**Proposed Composite Development (with Flat and Retail/F&B)
with Minor Relaxation of Plot Ratio Restriction
in "Commercial (2)" Zone at 8 Lam Chak Street, Kowloon
- S16 Planning Application –
TPB Ref.: A/K22/50**

(Planning Application No: A/K22/50)

RESPONSE-TO-COMMENT TABLE

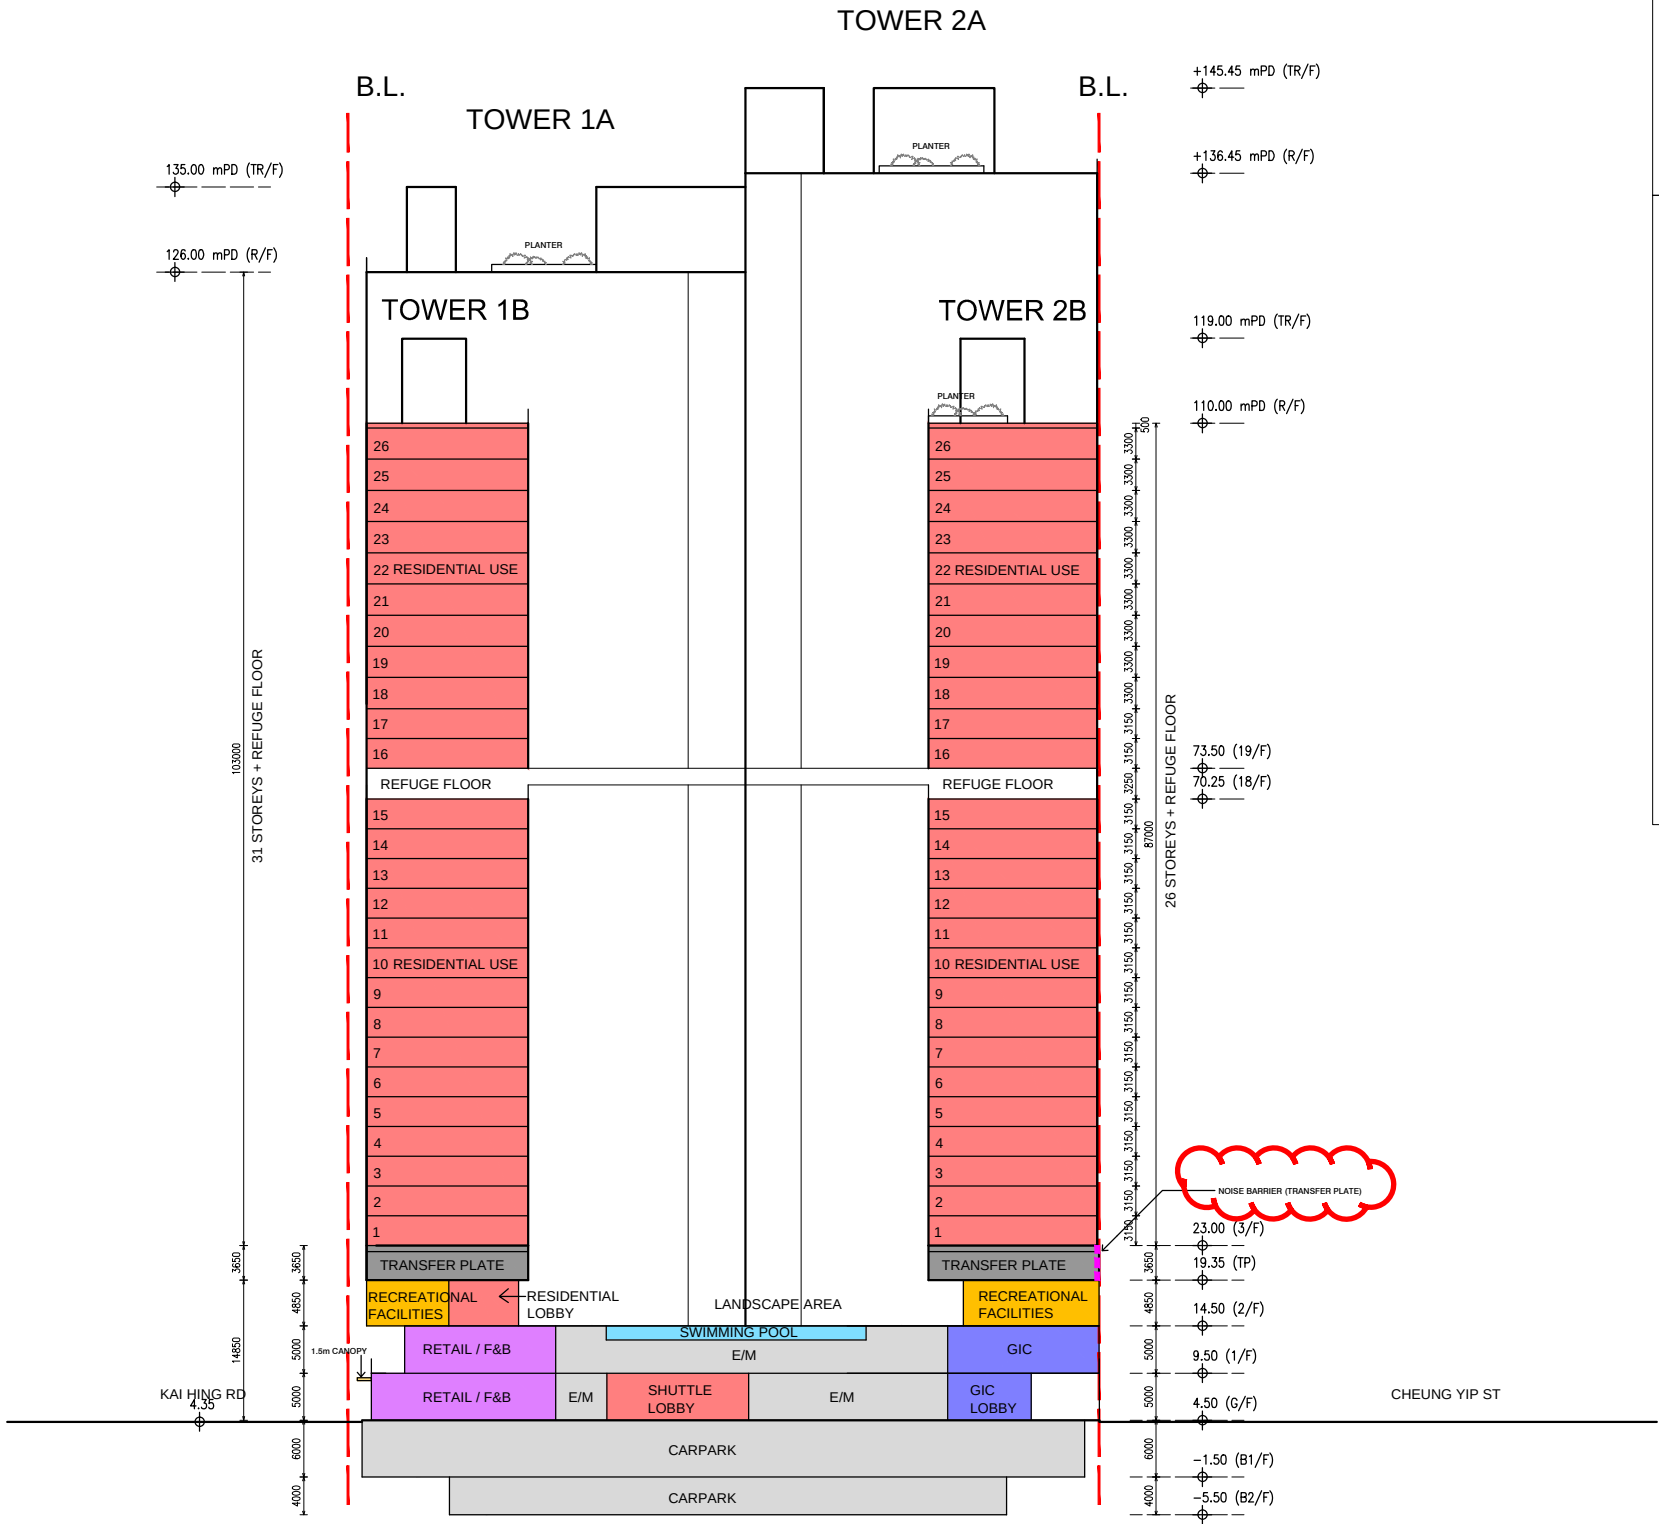
4. Section 7 Please confirm the validity and altitude of the flight path for NAH at the north side of the proposed development with the relevant authority.	Civil Aviation Department (CAD) and Government Flying Service (GFS) have been approached for the purpose to confirm this matter. Reply from CAD will be provided once available. According to the reply from GFS, the information of flight path for NAH remain valid. Section 7 has been updated accordingly and a new Appendix 7.1 has been added.
<u>Air Quality Impact Assessment</u> No further comments.	Noted.
<u>Land Contamination Assessment</u> No further comments.	Noted.

7.1.3 Enquiries were submitted to CAD and GFS in July 2026 for this study to clarify the validity of assumption in the EIA. Reply from CAD and GFS is included in **Appendix 7.1**. According to the advice from GFS, the information of flight path for NAH proposed in the EIA report is valid with no changes.

FIGURE NO.: 2.1 (REV B)		PROJECT TITLE: S16 Planning Application for Proposed Composite Development of Harbourside HQ at No.8 Lam Chak Street, Kowloon Bay	
PROJECT NO.: 25046HK		DRAWING TITLE: G/F LAYOUT PLAN	
SCALE: 1 : 700 @A4	DATE: 01 JUN 2026	 CTA Consultants Limited 志達顧問有限公司

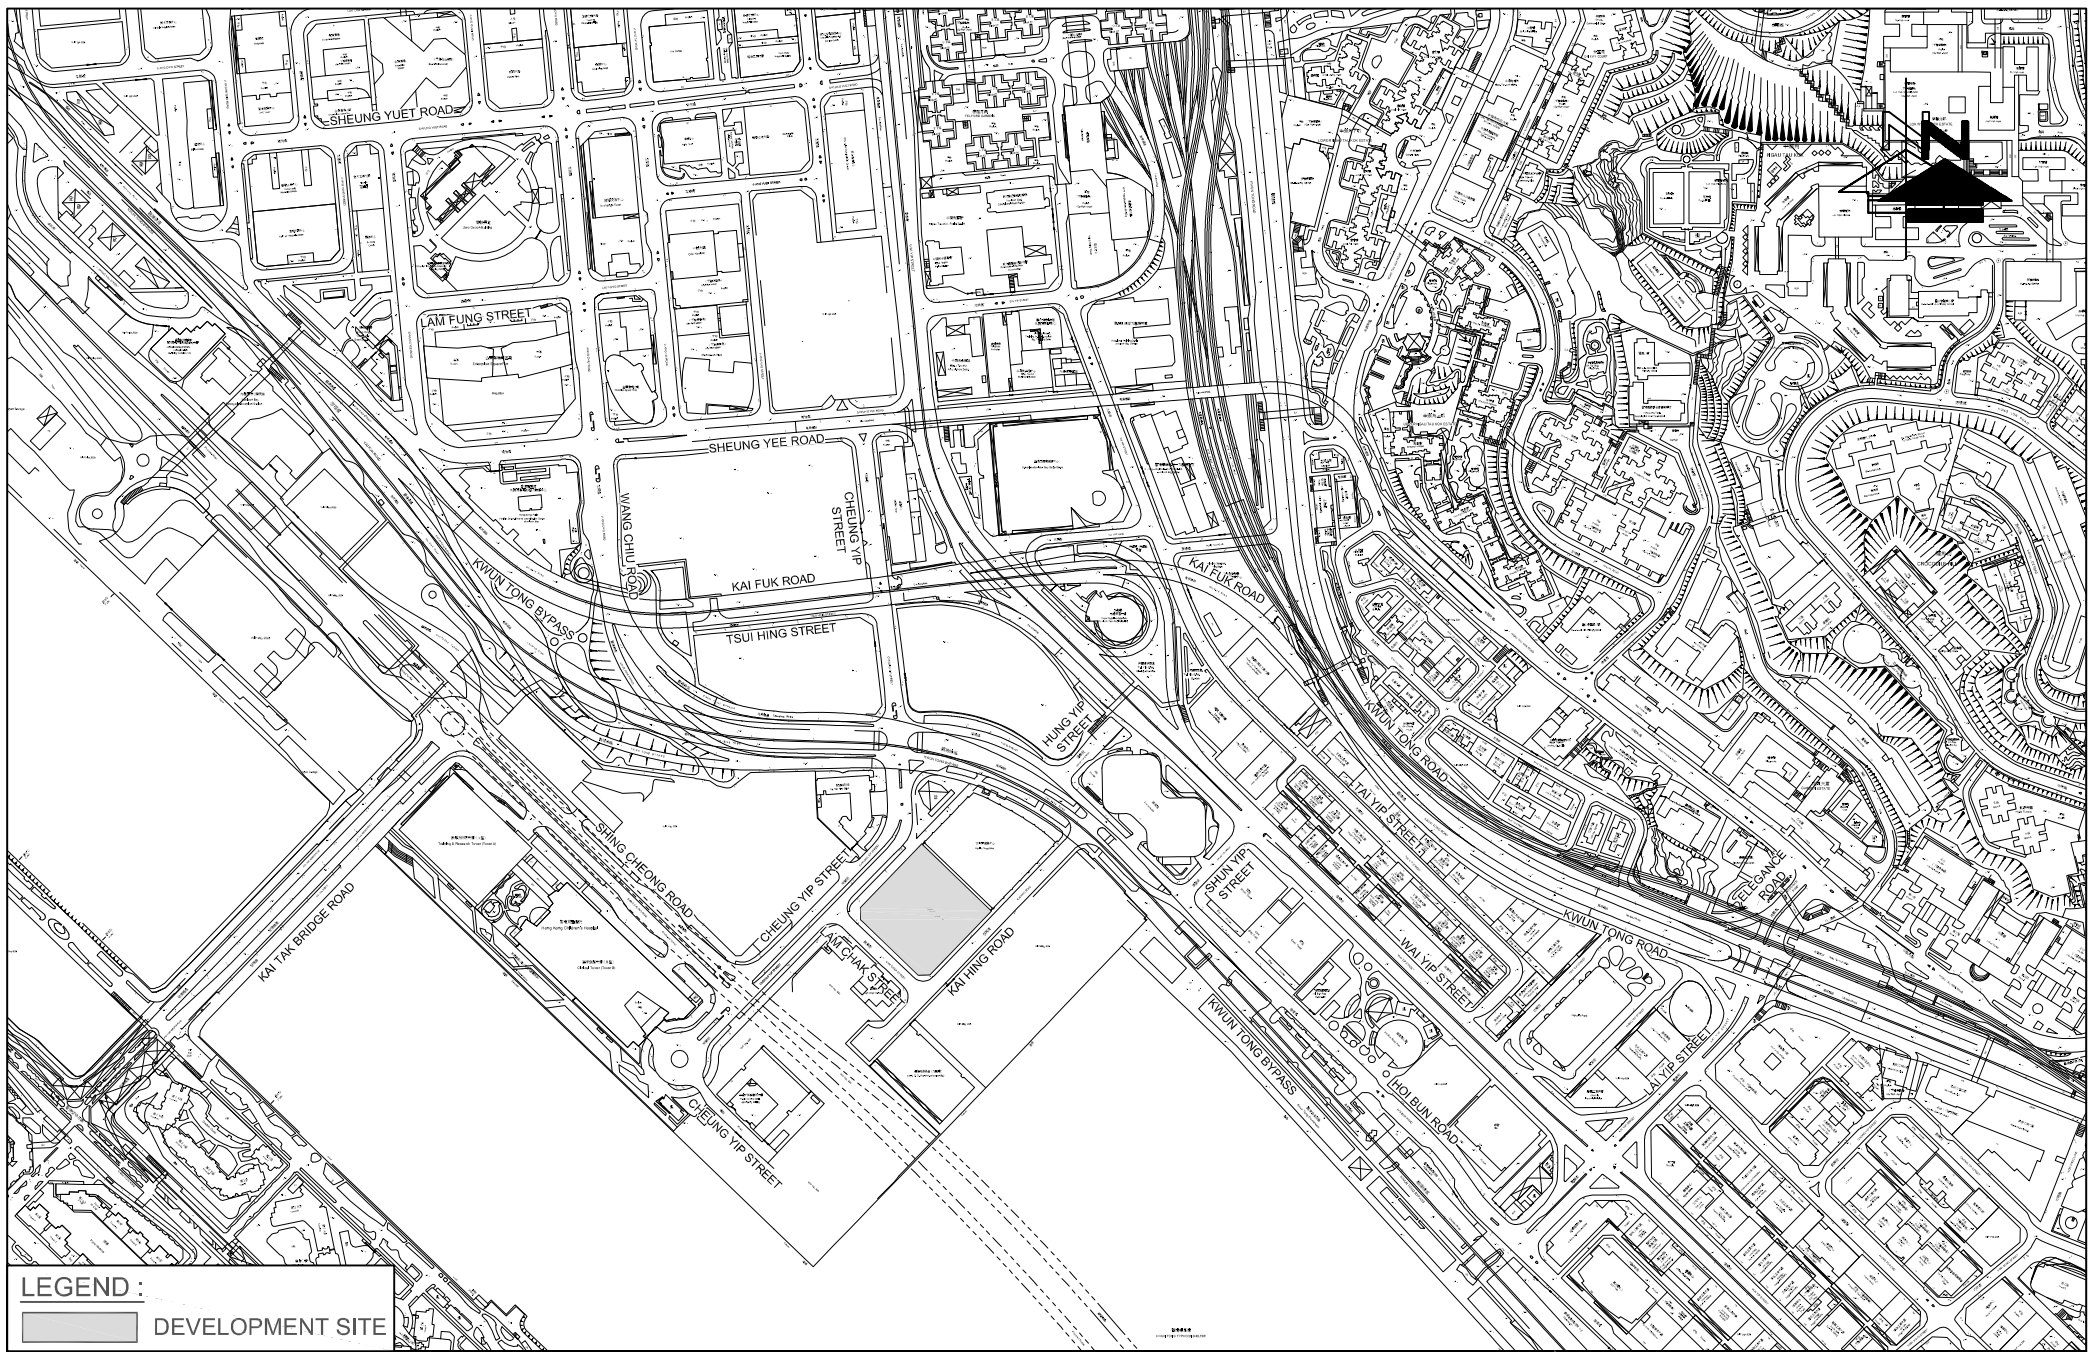
Comments	Response
- Para 7.1.7 - Please suitably revise according to the above comments. Please consider if any improvement/addition of bus/GMB stop(s) shall be arranged to facilitate the PT needs of the proposed redevelopment. - Figure 2.1(rev) - Please advice if the "shuttle lobby" means a shuttle lift lobby. This is the consolidated reply from Traffic Engineering Kowloon) Division and Transport Operations (Kowloon) Section of TD.	Para. 7.1.7 has been revised. Please refer to the revised TIA report in <i>Appendix III</i> for details. Please be advised that the "shuttle lobby" means a shuttle lift lobby. Noted.
<u>Comments from Social Welfare Department:</u> (Contact Person: Mr Michael Pang; Tel: 2116 5939) The applicant proposes to reserve about 490 square metres in GFA for provision of GIC facilities without mentioning the concrete GIC facilities that she wishes to provide. The applicant should indicate (i) what type of GIC facilities (e.g. welfare, public health, recreational, etc.) she wishes to provide in her s.16 planning application and (ii) the financing mode of the proposed GIC facilities.	The Applicant commits to reserve about 15% of the non-domestic GFA (i.e. about 490m²) for GIC uses to be operated by NGOs. This could serve as youth centre, childcare centre, nursery and etc. Section 3.1.2 has been updated accordingly (<i>Appendix IV</i> refers).
